RE: East of Aberline PSP community consultation

Thank you for the opportunity to view the documents and make a submission on the exhibited PSP. I am a nearby landholder and also have many years of planning and environmental expertise.

Examples of grassland species in flower on Tozer Reserve in spring:

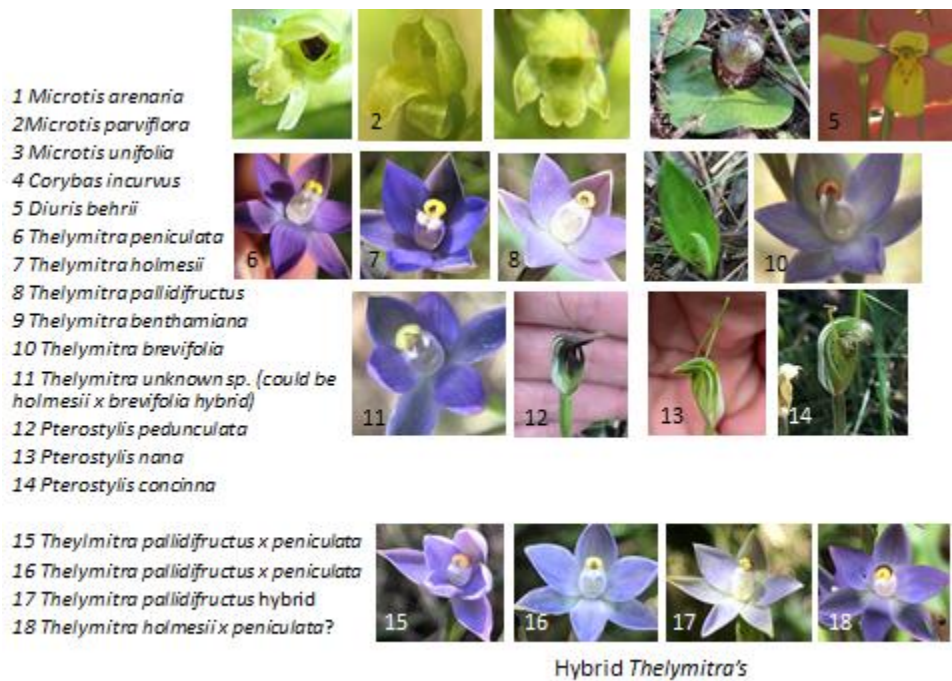
- It is the largest Plains Grassy Woodland remnant in Warrnambool and anywhere close to it. The ecological report suggesting it didn't meet the benchmark for this EVC was undertaken at a time of year that couldn't back up this assessment, as it was based in part on ground flora diversity (May has about 7 times less ground flora diversity visible than in October). The vegetation is also undergoing a period of active change thanks to restoration, and the final values of the site are still emerging. This vegetation community is underrepresented in the current public reserve system (by previous state government assessments), and is at threat of extinction over time. All remnant areas are important. This one is of particular importance due to its location in one of the most cleared parts of Australia. My ecological expertise and knowledge of the site leads me to believe it may be an even rarer subset of the listed community, as the species present are different to sites further north on the Victorian Volcanic Plain.

- There is a section of the reserve that is considered 'remnant' and wasn't under pines. With improved management, this area has transitioned to a Black Wattle overstory with 3 or more acres of predominantly chocolate lily understory that is visible in October. There are very, very few examples of remaining wildflower patches this large anywhere in the broader region (see some photos below).
